SERVICE NO. 1156D BULLETIN

Date: August 3, 2026

**PERIODIC INSPECTION AND REPLACEMENT OF
NOSE GEAR DRAG LINK BOLT**

Figure 1
Typical PA-28R/28RT Bolt Location

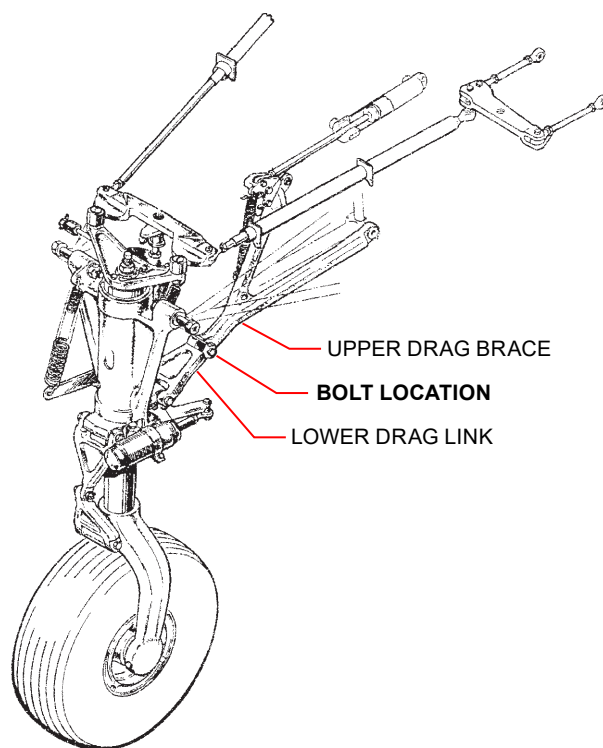
1. Jack the aircraft per the applicable Piper AMM or SM.
2. Disassemble the upper drag brace from the lower drag link by removing the NAS464P4-27 bolt that functions as a hinge pin for the two parts. See Figure 1 or Figure 2, as applicable. Discard the cotter pin, regardless of condition. The castellated nut, washers and bearings may be reused, depending on condition.

- If the TIS of the bolt is 500 or more hours: replace it with a new NAS464P4-27 bolt, regardless of condition.
3. Before installing the bolt, inspect the bearings for excessive wear and verify the inner diameter of the bearings are within the range of 0.2495–0.2515 inches. Replace bearings (Piper P/N 452-800) on condition.

If new bearings are installed, perform a final reaming operation, on the upper drag brace only, to achieve an inner diameter of 0.2495–0.2505 inches through both bearings.

NOTE: The nose gear drag link assembly is comprised of two major components: the upper drag brace and the lower drag link. The line ream operation described above applies only to the upper drag brace, and does not apply to the lower drag link. See Figure 1 or Figure 2, as applicable.
